# Staff Report – Planning & Zoning Item

**Date:** February 16, 2016  
**Case No.:** P-16-01  
**Request:** Preliminary Plat  
**Applicant:** Wildcreek LLC

P-16-01 Consider a preliminary plat for Mystic River, Phase II, a 9.99 acre tract of land, located east of North Main Street, west of the Leon River, and south of the existing Mystic River, Phase I subdivision.

**Project: Mystic River Phase II, Preliminary Plat**

C1.1

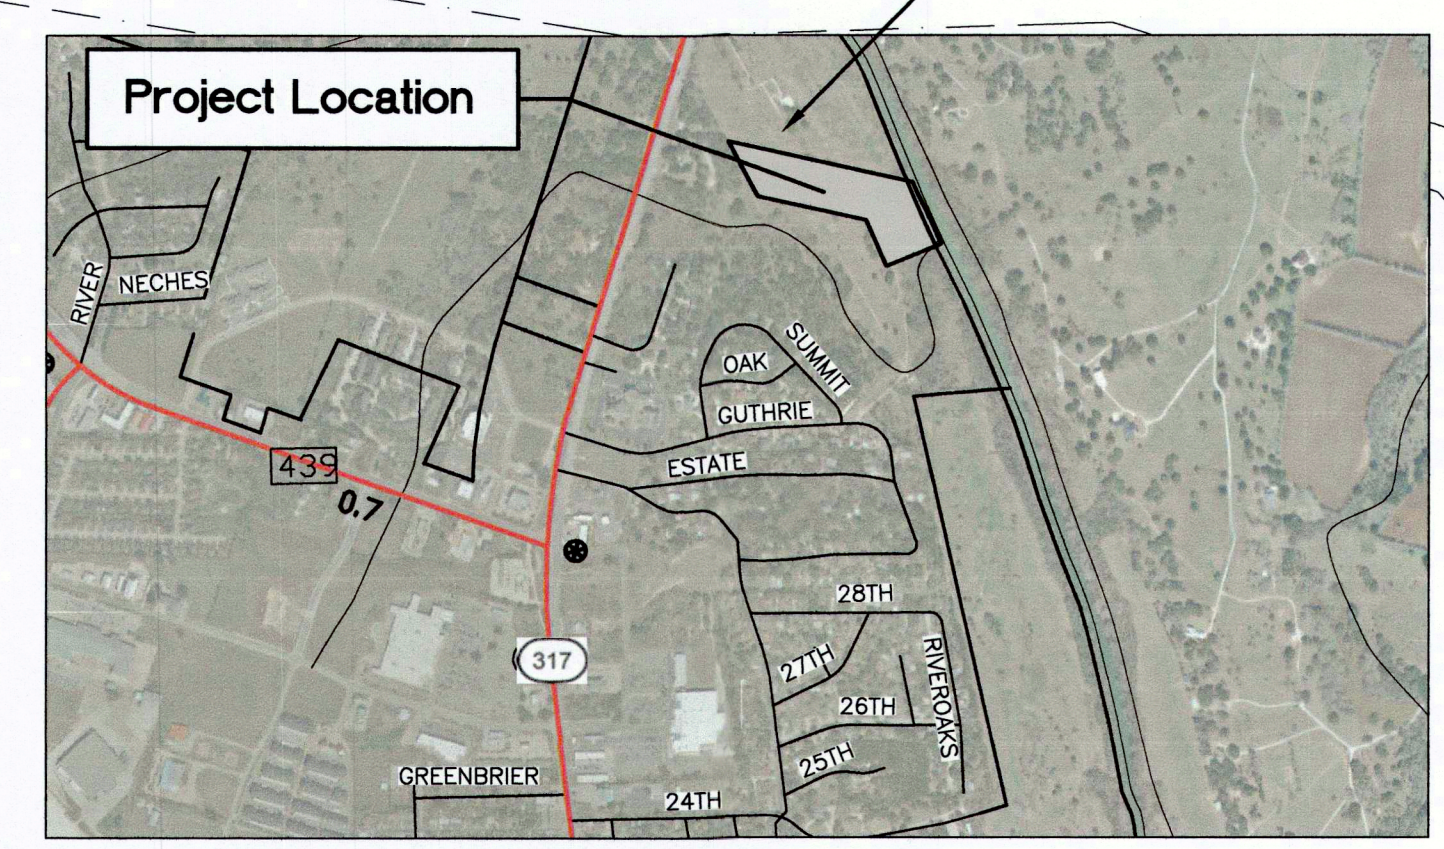
1. Mystic River Drive is shown as a collector street. Please revise the pavement width to 37 feet back of curb.
2. When the tree survey is submitted with the final plat, please include a list of protected trees 20 inches and larger and state whether the tree is being removed or saved.
3. Please submit restrictive covenants in conjunction with the final plat submittal.

1. Please submit a geotechnical report and drainage report for staff review.
2. Public Works and the applicant's engineer have discussed the drainage issue around the existing lift station. The City approves the Engineer's proposal to core the rock rip rap to drain the water that ponds in that area.

3. Please provide a proposed grading plan with the final plat submission.
4. The existing sewer is shown to be just outside of the right-of-way at Block 2, Lot 7. Please adjust the roadway so that the sewer line is within the right-of-way. Please also adjust the waterline to between back of curb and right-of-way line.

5. Verify the 10-foot wide sewer line easement. Staff believes this easement is 20 feet wide to accommodate the deep sewer in this area.
6. Please provide record drawings for the off-site sewer and lift station in Phase I.

7. Provide a street light at the curve by the storm drain curb inlet.
8. The end of line flush assembly on the 8 inch waterline shall be automatic and can be relocated phase to phase as development continues.

9. Install a gate valve at the end of the 8 inch waterline at the tee for the hydrant.
10. Install three gate valves at the tee of Mystic Drive and Pecan Praline. One of the valves can be used as the flush assembly valve.

11. Please ensure the sewer line to the west will serve Lot 1, Block 1.
12. Consider installing all dry utility conduits at time of street construction.

13. Add finished floor elevation on lots affected by the flood plain.
14. Avoid cross drainage from lot to lot.
